Air Leak/Fuel Restriction-Plastic Fuel Tank – 6.6 Gallon

Models: All Mercury and Mariners shipped with the 6.6 gallon plastic fuel tank

Figure 1 Fuel Tank (Plastic 6.6 Gallon)
P/N 1259-812410A1

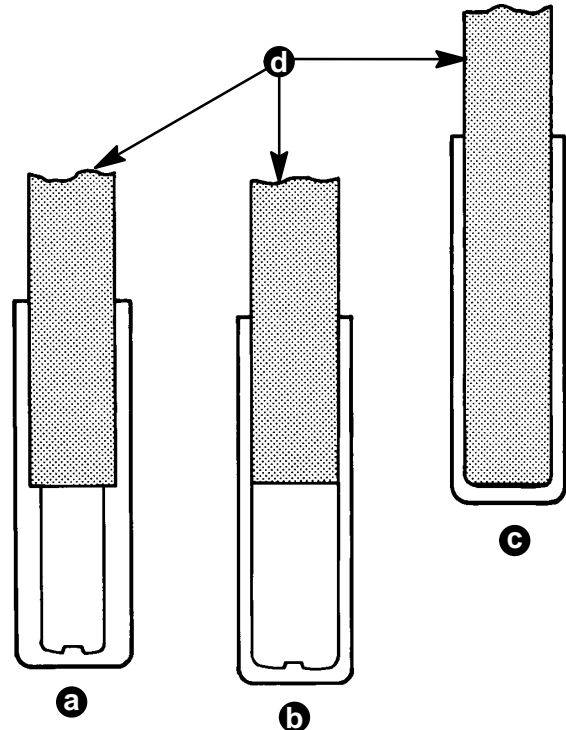
Air Leak: Fuel tank may have an air leak in the fuel pick-up. The brass threads of the adaptor (Figure 1) may not have any sealer on the threads. Tanks supplied with engines and Quicksilver stock listed require inspection of the fuel tank pick-up assembly.

Remove adaptor from pick-up body assembly.

Figure 2

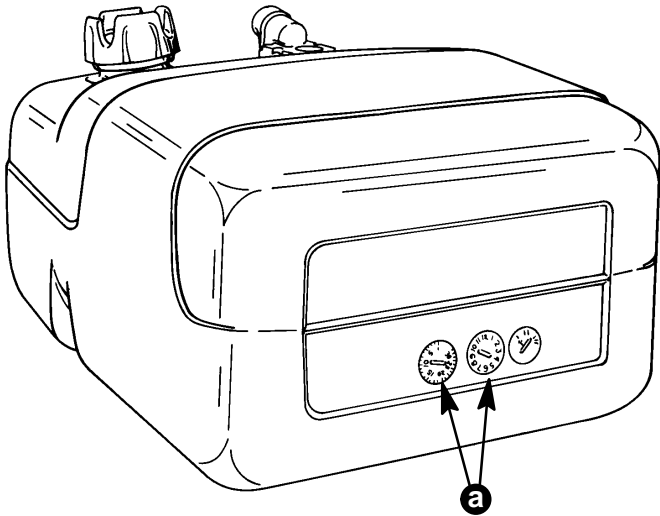
Fuel Restriction: Fuel tank may contract due to varying weather conditions. If sufficient contraction takes place, the pick-up filter could restrict fuel flow to the engine (Figure 2). This is caused by the pick-up filter bottoming out when the tank contracts, pushing the filter up on the pick-up tube.

Fuel Filter Restriction: Remove the fuel filter from the fuel pick-up line and discard it. Install a new filter (P/N 35-18029) in its place. The fuel filter is shouldered, (Figure 2).

Figure 4

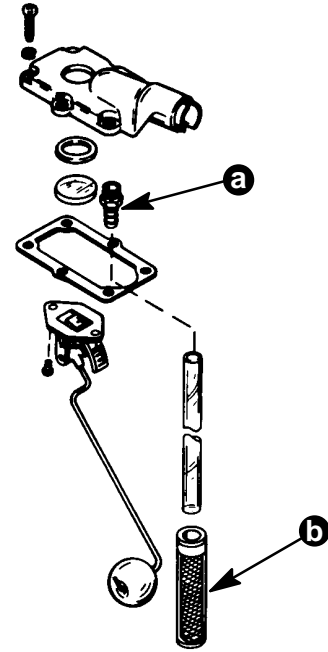
Air leak: Apply a light coat of Perfect-Seal (P/N 92-34227--1) to the adaptor threads (Figure 4).

Figure 5 Pick-up Body

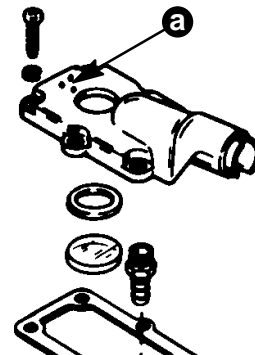
Mark the pick-up body using a centerpunch. Three punch marks (Figure 5) in a triangular formation, (:.). Use a small dab of paint on the punch marks to prevent corrosion. This will aid your dealership in future service identification.
